FINAL DRAINAGE REPORT

FALCON RANCHETTES FILING NO. 1A
MERIDIAN STORAGE
El Paso County, Colorado

PCD File No. VR239 & PPR2336

Project: **Falcon Ranchettes Filing No. 1a (Meridian Storage)**

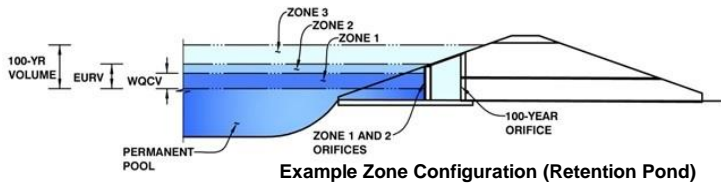
Saw the comment responses, the justification makes sense. Please add this discussion to the report text under the Proposed Pond #1 Full Spectrum EDB section so it is documented outside of the response document.

Added paragraph under requested section.
